COMMITTEE UPDATE SHEET

SUPPLEMENTARY REPORT OF THE PLANNING MANAGER

22/00168/FUL – Land off Farm Lane, rear of Barn Cottages, Hardstoft

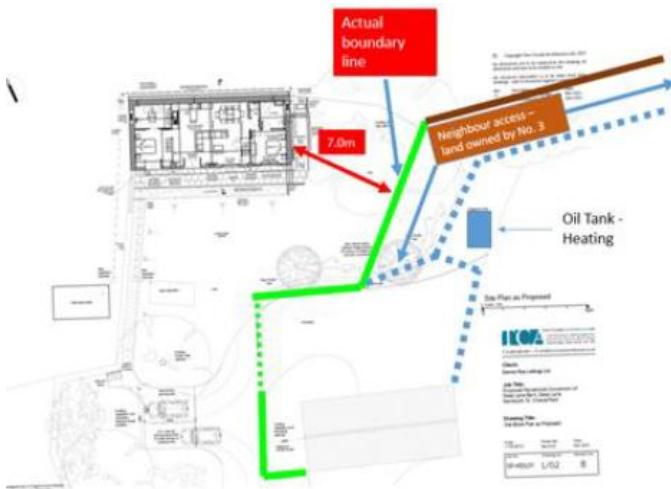
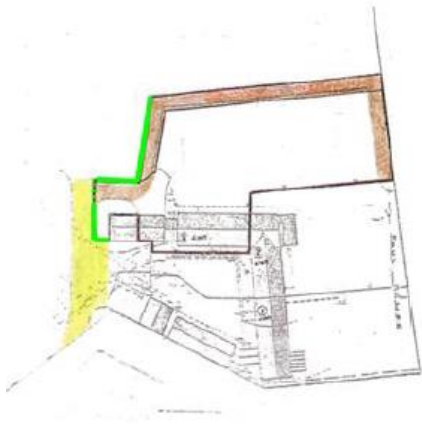
8. Boundary lines are incorrect and inconsistent throughout the application on the existing boundaries and also extended boundaries impacted the local Conservation Plan. The applicant states the “neighbour has access over this area” which is incorrect as it is owned by barn number 3. I have included below a copy of the actual boundary line against title deeds held. It demonstrates that the applicant has made incorrect provision to the Eastern boundary of the development. This encroaches on to land owned by barn number 3 and is neglectful by the applicant as it makes the proposed windows not viable given the distances detailed by the

planning manager. A boundary dispute has been sent to the applicant by the owner of Barn number 3. I have also included photos below that correspond to the boundary on the title deeds (note the location of the private driveway and also start of the strip owned by Barn 3 but access for barns 1&2 in line with the garage as per the plans and designated by a cone)

The “pitching hole style window” to the East gable end would be directly overlooking the private garden of number 3 Barn Cottages. – This is commented upon in the planning manager’s summary of the proposal. It details the measurements from the barn to the boundary. This is incorrect as the boundary line is incorrect on the applicant’s plans. The actual boundary is only 7m meters from the barn and therefore the windows are not suitable and should be rejected as such. The photo (top right) shows the actual boundary and the fact the property is only 7.0m from the boundary, designated by cones.

With regards to point 8 above, the Local Planning Authority has visited the site and measured a distance of 12m from the proposed first floor, side facing bedroom window onto the stone wall boundary and private garden behind, serving Barn 1. This is in excess of the 10.5m recommended in the Successful Places Design Document. Whilst the stone wall is low on this boundary, there is substantial planting along the part of the boundary closest to the proposal, and there is also a mature tree within the application site that will screen views out of the window to some extent. Whilst the Local Planning Authority acknowledge and accept that Barn 1 owns and maintains a strip of land around the edge of the eastern boundary to provide access to the rear of Barns 1, 2 and 3, this strip of land is not included as part of Barn 1's domestic curtilage, which is clearly defined by the existing stone wall. The Local Planning Authority therefore considers that the proposed side facing bedroom window does not overlook the private amenity space serving Barn 1 sufficient to warrant a reason for refusal, or condition requiring the proposed window to be obscured glazed and non-opening.

Point 8 above also makes reference to the strip of land required for access to barns 1, 2 and 3. It is disputed that Barn 1 owns additional land within this area, which has been included in the application site boundary, and within ownership of the applicant. The Local Planning authority carried out a Land Registry check on the 15th July for Barn 1 to establish where the boundaries are positioned. An extract from that plan is provided below (left image) along with an extract from the amended L/01 Rev E received on the 21st June.

The position of the red line boundary appears to have been drawn correctly on the plans submitted with the application, in comparison with the red line on the official title plan. Notwithstanding that, an advisory note is recommended for inclusion to remind the applicant that in the event a land ownership dispute results in the red line boundary being drawn incorrectly on this application, or a failure to formally notify other land owners within the application site, it could render the application invalid and a revised application be required. The applicant's representative was emailed on the 15th July to ask *"Given that there are some shared access provisions, and shared boundaries with other land owners, are you now confident that all land contained within the application site (red line) boundary is within the sole ownership of the applicant, as stated on the signed Part A ownership certificate."* The applicant's representative responded with *"Yes, it is my understanding from the Client that the plans are accurate in that matter."* It is therefore considered that the Local Planning Authority has taken appropriate steps to confirm that the application site boundary is correct, and has informed the applicant of potential consequences if plans are inaccurate.

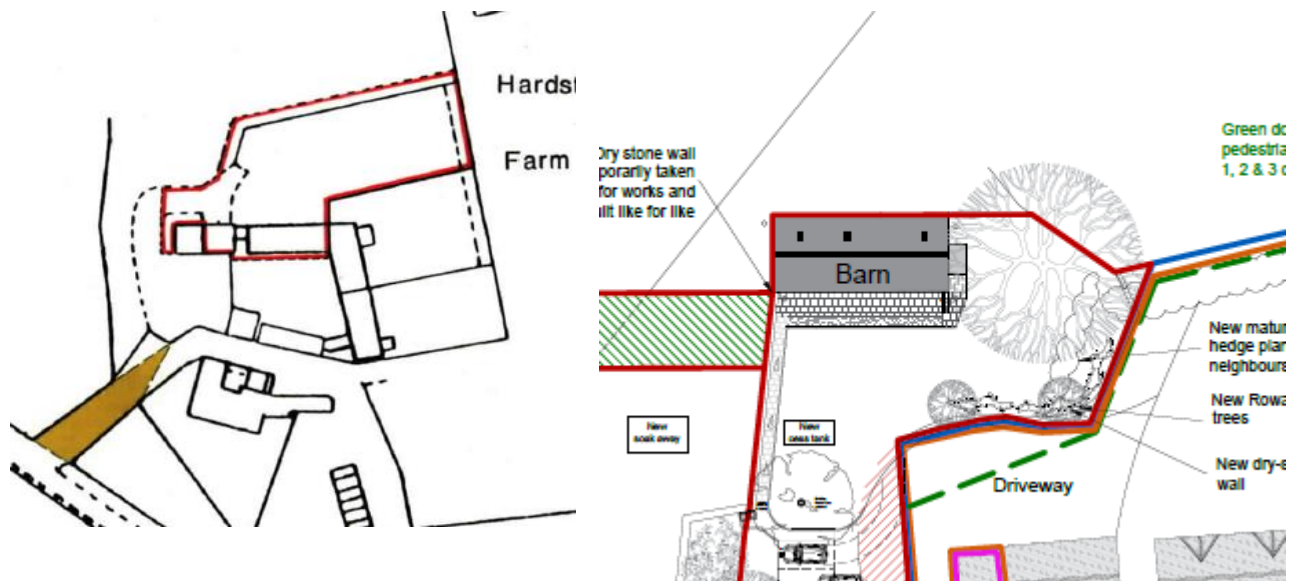
11. There is a lack of turning available in the site as well as in the parking spaces. The incorrect boundaries are misleading making something achievable which is not, the pictures of the driveway above show a single track driveway. As the plans have been revised since Highways reviewed the project originally but I question why the council has not sent this back to the highways for further comment?
